GreenStar™ Software Update 2016-1

Release Notes

Application Controller 1120: John Deere Mobile Weather

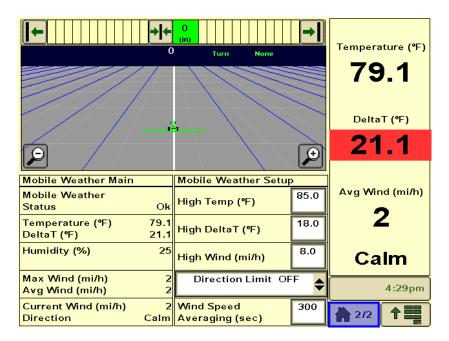
Displays wind speed - John Deere Mobile Weather now displays maximum wind speed, average wind speed and calm status. The window for averaging weather data has been increased to 600 seconds, allowing you to further customize averaging data.

Max Wind (mi/h) – Highest data value collected during your set "wind speed averaging" interval.

Avg Wind (mi/h) – Average of data collected during your set "wind speed averaging" interval.

Calm Status – Is displayed when average wind speed is below 3mi/h for your set "wind speed averaging" interval.
